Product / Process Change Notification (PCN)

PCN Number: PCN_IndCMBH_20240503

Affected Series: WE-CMBH

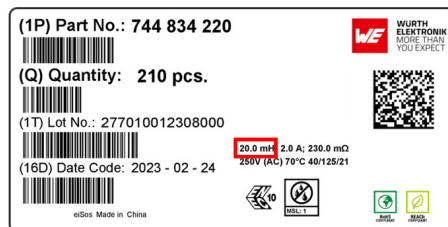
The international standard IEC 60938-2 is now requiring to print the inductance tolerance on the packaging label:

The current label doesn't show any inductance tolerance

The inductance value will be shown with tolerance
